Swedish Radiation Safety Authority

Technical Note

2014:05

Assessment of flows to
deposition holes

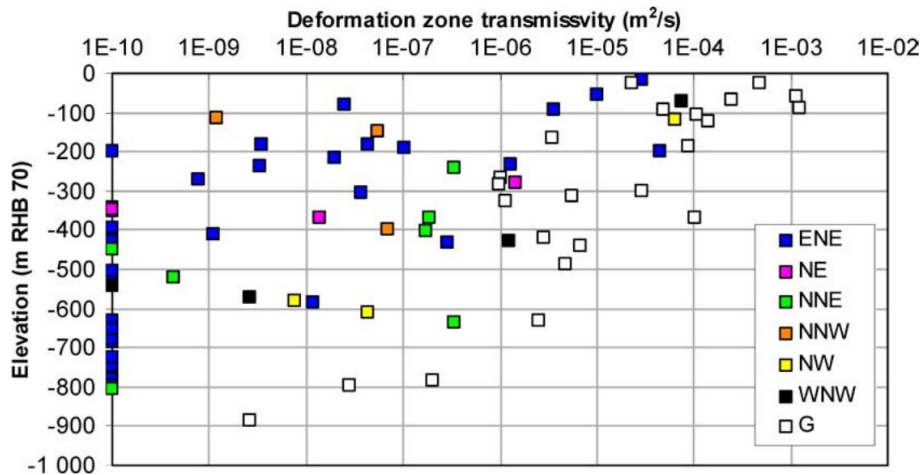
The first assumption, as pointed out in the initial phase of this review, is only strongly supported by data for the gently dipping HCDs (Figure 2.4). As commented previously (Geier, 2011a):

The transmissivity data from deformation zones could just as well support an alternative interpretation in which only the gently dipping zones show a regular pattern of transmissivity decreasing with depth, while the steep zones are essentially random (dominated by heterogeneity which ranges over 5 orders of magnitude) in the interval -100 m to -600 m, then predominantly tight below -600 m. However, such an interpretation, or any other alternative to the assumption of a single trend with depth for all zones, has not been tested for SR-Site.

This argument is unconvincing, since even in a model that includes a few isolated high-transmissivity patches in predominantly tight deformation zones at depth, the flows will tend to be dominated by the surrounding, tighter portions of the zones. However, the authors' further argument, that the effects of the HCD model on flows to deposition holes are mitigated by the properties of the DFN model for the HRD, is in line with the conclusions of this review.

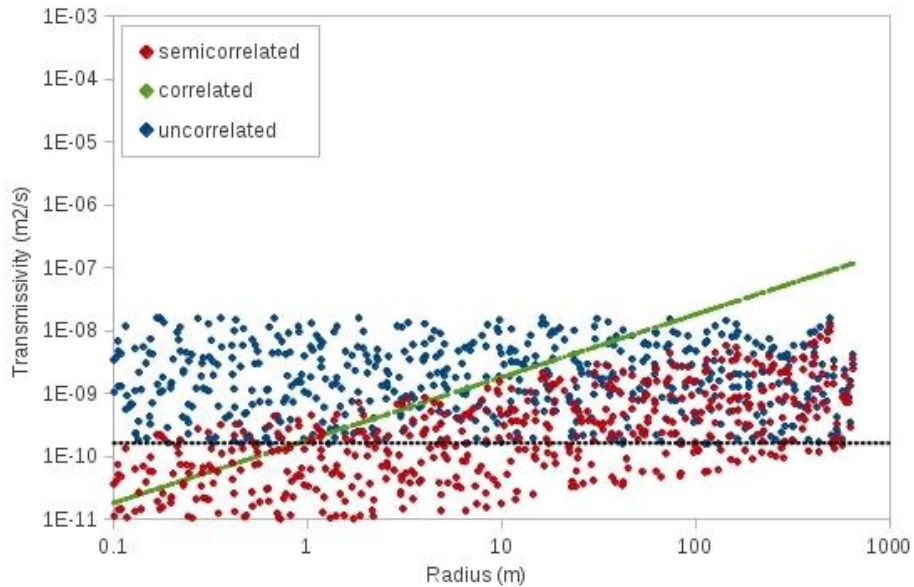
holes. It can be seen that the transmissivities assigned by the semi-correlated model imply that most fractures from the scale of the borehole radius up to about 10 m radius are invisible to the PFL measurement method.

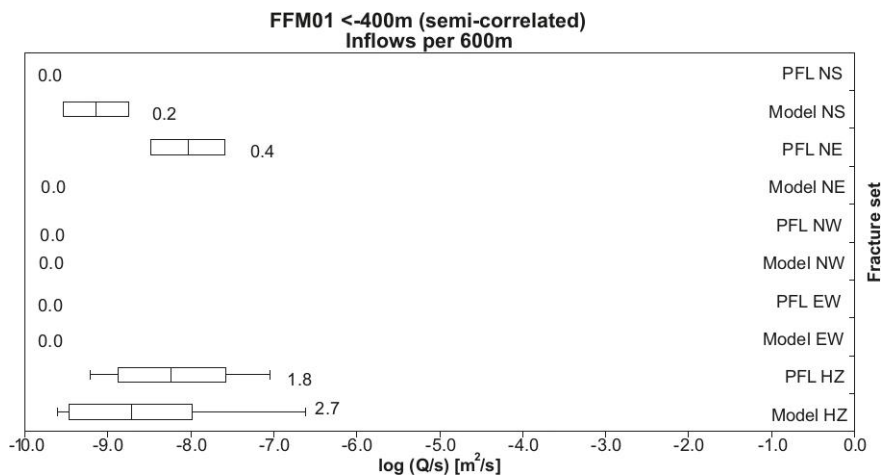
From this plot it appears that the model, on average, under-predicts the magnitudes of PFL anomalies associated with both horizontal and subvertical fractures. For subvertical fractures the model assigns inflows to the N-striking set rather than the NE-striking set where they are observed. For the subhorizontal fractures that are associated with most of the PFL anomalies, the model predicts a variance of Q/s similar to the variance of the measurements, but a wider spread of extreme values. Unfortunately the presentation does not indicate how much of this variation is due to differences between stochastic realizations.

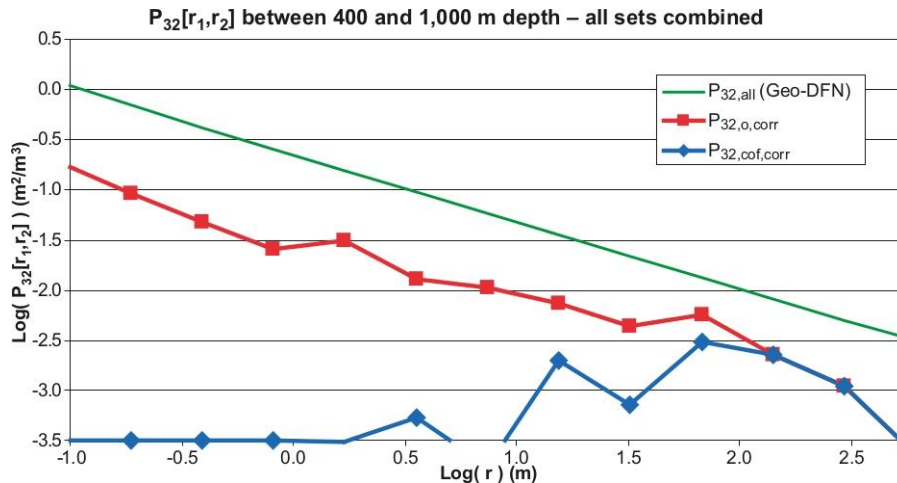
The third paragraph was addressed in part by Appendix C of Follin (2008), including the plot that is reproduced as Figure 3.7 of this technical note. This plot, based on a single realization of the Hydro-DFN model, addresses the question of geometric consistency by comparing the total fracture intensity of fractures (as a function of radius) in the Geo-DFN model, versus the total intensity of open fractures in the Hydro-DFN realization for FFM01 below -400 m.

The use of a single stochastic realization leads to some uncertainty, particularly with regard to open fractures larger than 100 m which (in Figure 3.7) appear to exceed the total fracture intensity for the same sizes of fractures, in the Geo-DFN. This is possibly an artefact of the stochastic simulation in a finite generation region, which can lead to excessive generation of large fractures when using a power-law distribution.

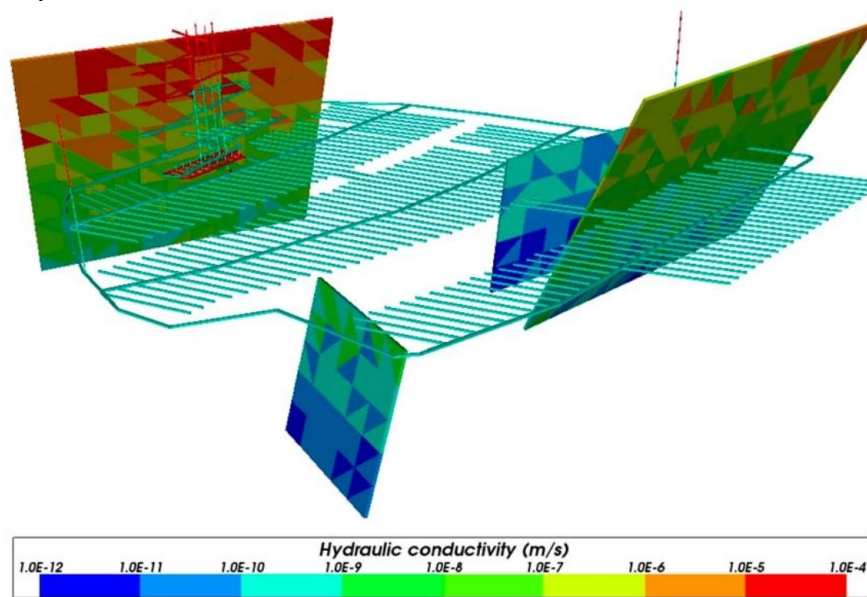
From the color scale in Figure 4.2, the hydraulic conductivities assigned to these features at repository depths are in the range 10⁻¹⁰ m/s to 10⁻⁸ m/s. The widths assumed for this variant are not listed in the main hydrogeological modelling reports, but assuming a width of 10 m, this corresponds to a transmissivity range 10⁻⁷

10^{-9} m²/s to 10^{-7} m²/s. By comparison with Figure 3.4, this range is about an order of magnitude higher than the transmissivities assigned to similar-sized fractures in the central (“semi-correlated”) variant of the Hydro-DFN model for similar depths, but about the same as for the “correlated” variant.
